To: anthony.brown@bp.com[anthony.brown@bp.com]
Cc: gr@burlesonconsulting.com[gr@burlesonconsulting.com]; Mike Johnson[mike.johnson@copperenv.com]; Doug Carey[douglas.carey@waterboards.ca.gov]; Cory Koger[Cory.S.Koger@usace.army.mil]; tavassoli, lily[tavassoli.lily@epa.gov]
From: Deschambault, Lynda
Sent: Wed 4/12/2017 5:16:46 PM
Subject: RE: Leviathan Mine Aspen Seep Bioreactor update

Subject: FW: Leviathan Mine Aspen Seep Bioreactor update

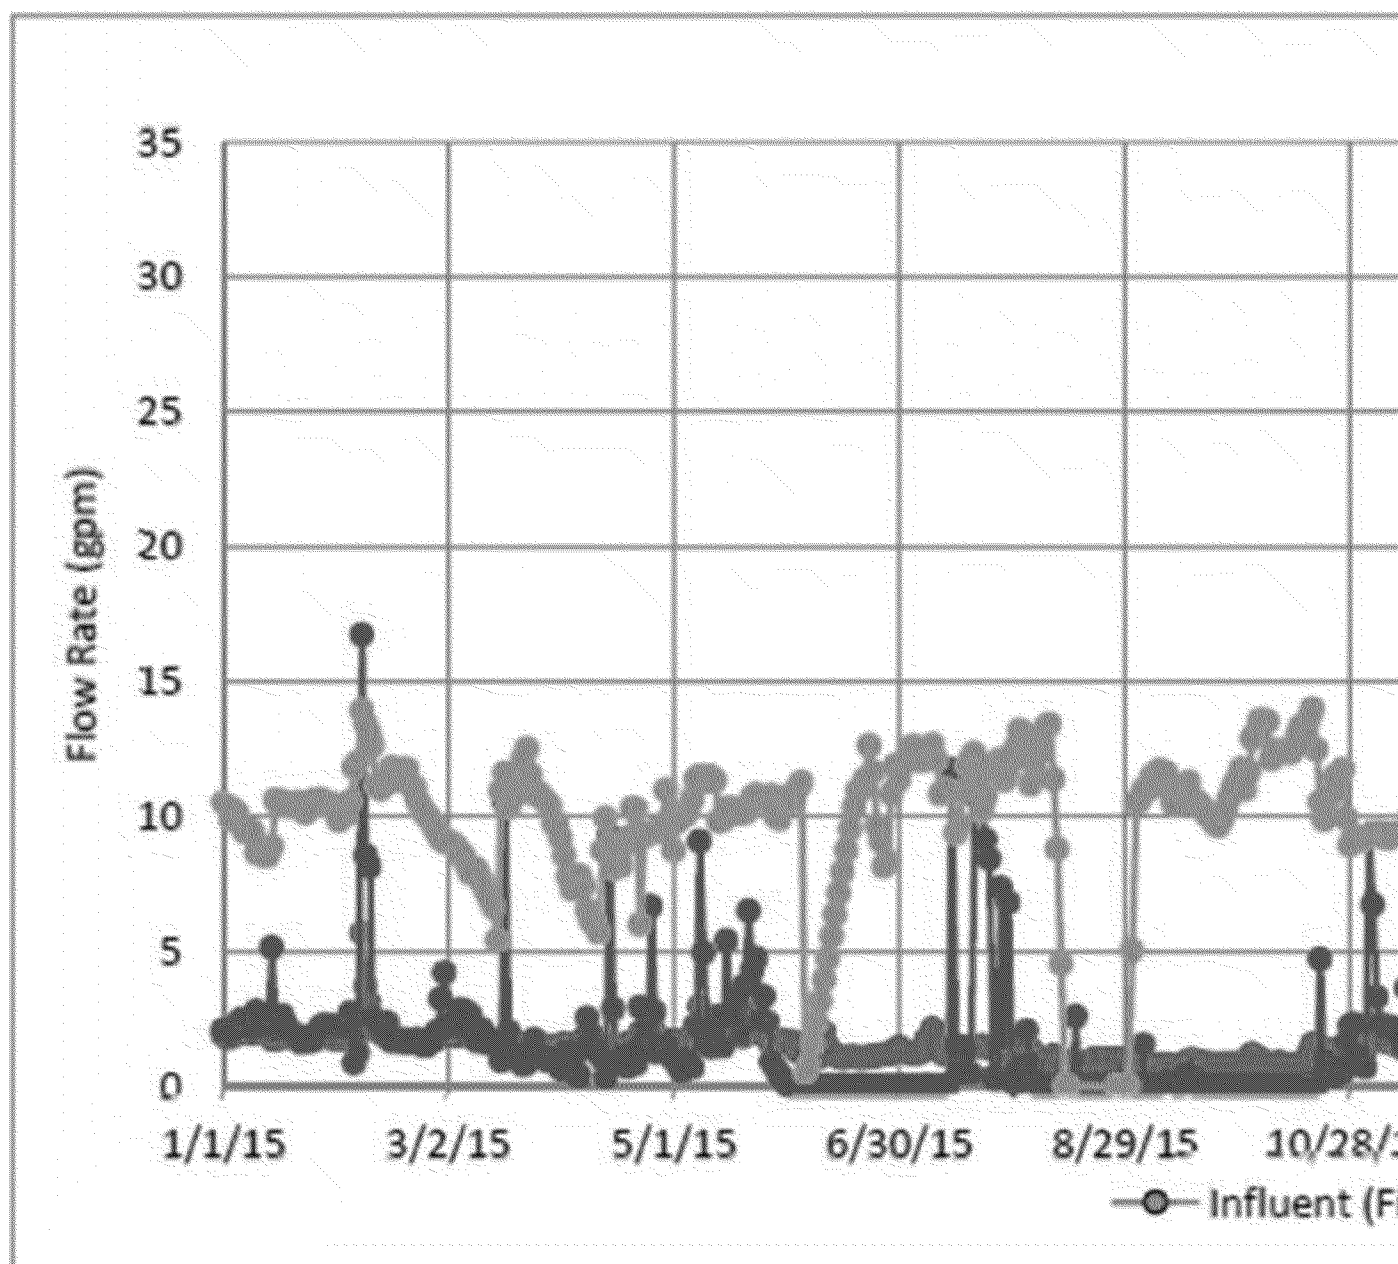
1) **Flow Rates:** Could you please provide some additional updates on charts and figures regarding flow, freeboard etc? For instance this one:

Please see the chart below which illustrates the recent influent flow rate (field measurements) and effluent flow rate data from the Aspen Seep Bioreactor (ASB) Treatment System. We have not received the downloaded influent flow rate data since 12/31/16; however, our approximately monthly field measurements are shown on the chart. In addition, the influent flow rate was manually measured at approximately 25 gpm during the 4/6/17 field visit. As we have had to temporarily remove the 1" effluent flow meter, we will not have effluent flow rate data until it (or a larger 2" flowmeter) can be re-installed. During the 4/6/17 visit, the debris at the launder was removed, and the Pond 4 water elevation was lowered through the use of a siphon. The 1" section of discharge piping and the 1" flowmeter was replaced with 2" flexible piping. The new 2" piping was flowing at approximately 100 gpm while the Pond 4 elevation was lowering (see attached photo). At the time that the maintenance crew left the site, the effluent flow rate had still not yet reached equilibrium.
